**DEVIATION REQUEST  
AND DECISION FORM**  
Updated: 6/26/2019

Project Name : Eagleview Subdivision  
Schedule No.(s) : 5226000001), 5226000001)  
Legal Description : N2NW4 EX WLY 620.0 FT SEC 26-12-65,S2NW4 EX WLY 620.0 FT SEC 26-12-65

**DEVIATION No. 4 (Revised 10/28/2022)** A deviation from the standards of or in Sections **2.3.4.A.1 and 2.3.6.G** of the Engineering Criteria Manual (ECM) is requested. Three exhibits are included with this deviation.

Exhibit 1

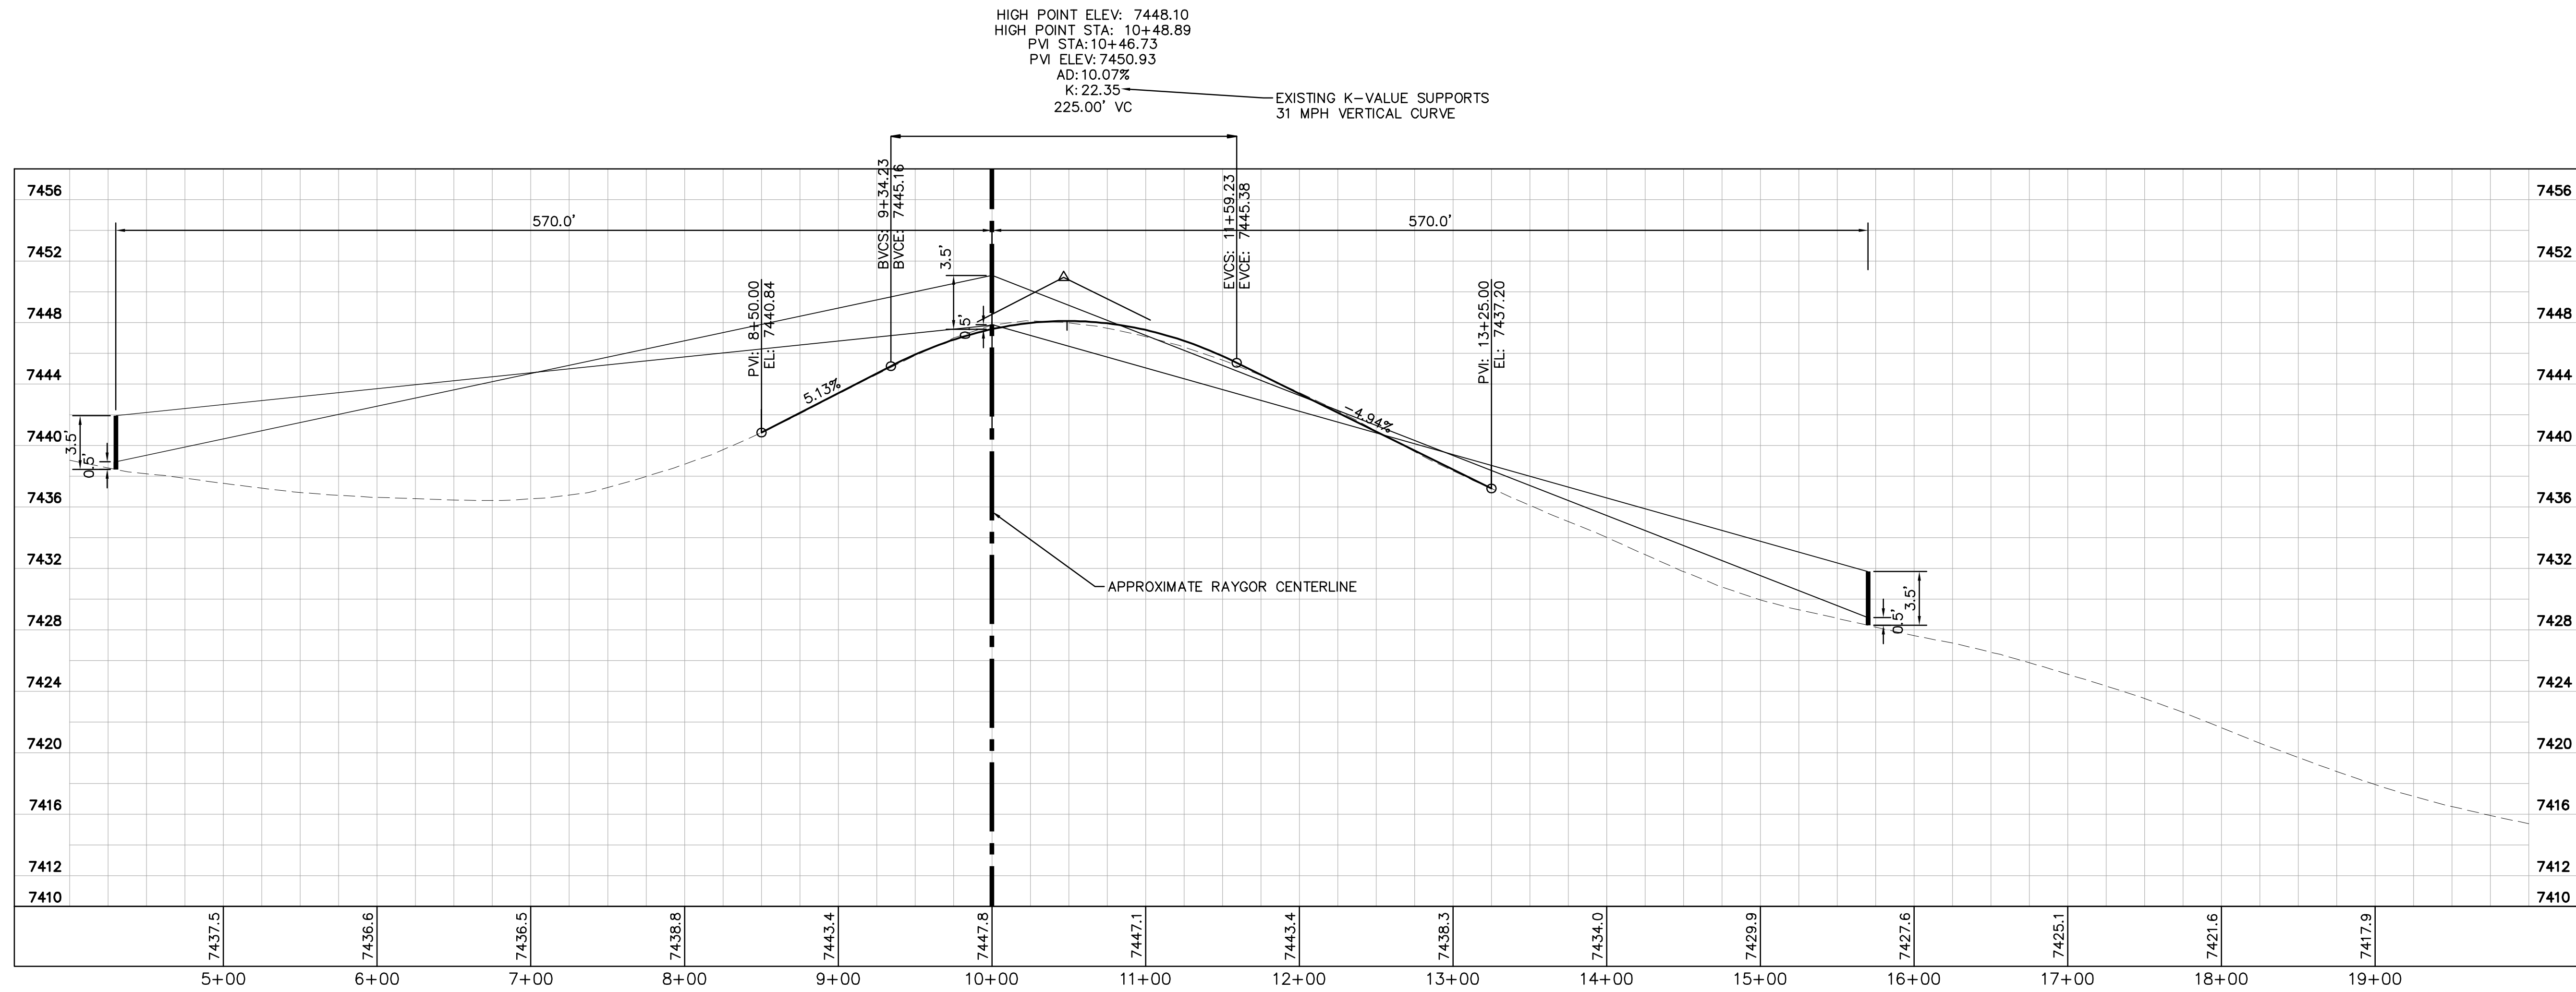
- The crest vertical curve on Burgess Road at the Burgess Road/Raygor intersection does not meet the requirements for stopping sight distance and K value by roadway design speed, which is 60 mph (based on the roadway classification of Minor Arterial – posted 45 mph). Please refer to Exhibit 1 showing the subject location.

Section of Burgess for which Deviation #4 is requested

This request has been determined to have met the criteria for approval. A deviation from Section 2.3.4.A.1 and 2.3.6.G of the ECM is hereby granted based on the justification provided.
